Business Unit: HARTING Electronics **PCN/20/013/PM+MD-US**

Product range: M12 PCB Receptacles **Date:** 2020-10-28

Title: M12 D-code Angled PCB Receptacles **Page** 1/2

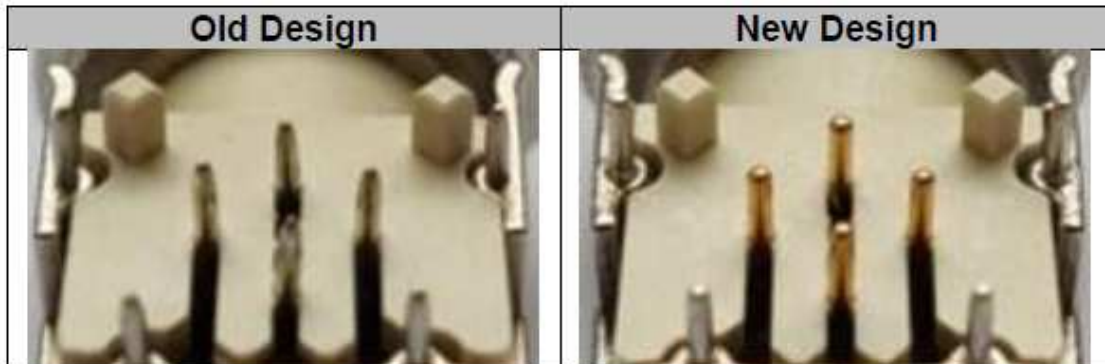
Replacement of the 2-piece contact design with 1-piece contact design. The new 1-piece contacts are gold plated while the old 2-piece design was nickel plated. This change has been implemented to achieve improved manufacturing process.

This change does not have an impact on fit, form or function of the products. The footprint of the M12 PCB receptacles will remain unchanged.
